Denial

Subject: Mine Ventilation Plan, Section 75.370, 30 CFR, Upper Big Branch Mine-South, I.D. No. 46-08436, Performance Coal Company, Montcoal, Raleigh County, West Virginia

Ventilation Plan

Internal Bleeder System Utilizing Barriers
For Multiple Sections of Small Center Rooms
(Drawing 12)

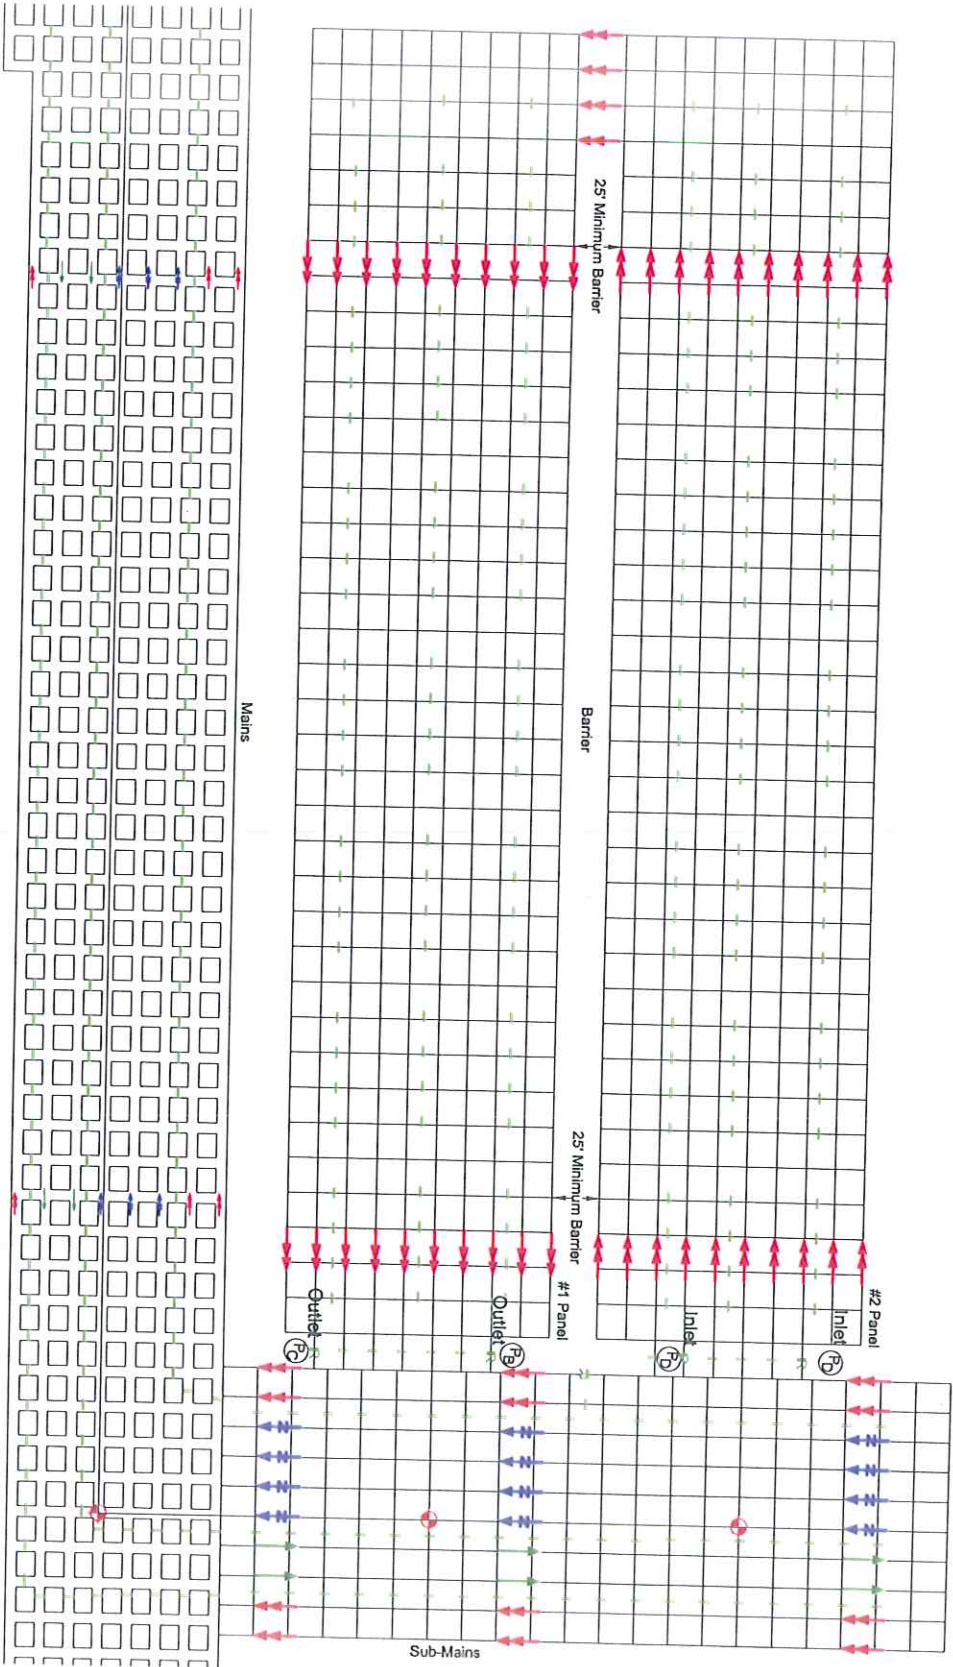
- The panels will be connected, at the point of furthest development, as shown on Drawing 4.
- Bleeder controls will be installed at the mouths of the panels typically as shown. All permanent ventilation controls will be plastered. *REMOVE*

- Evaluation points will be established at P-B, P-C, and P-D for weekly evaluations.
- The returns will be properly regulated to insure air movements through the bleeder. Air will typically enter P-D and exit P-B and P-C. Under some ventilating conditions, the airflow may differ. Airflow will, however, be maintained at the evaluation points. *AIR ENTERS LAST PANEL EXITS ALL OTHER PANEL*

- Any mining of a main or sub-main, whether it is rooms or a pillar section, is considered a panel.
- If additional panels are mined, air will exit the first panel mined (at P-B and P-C) and enter at all subsequent panels (at P-D, P-E, etc.). *REMOVE*
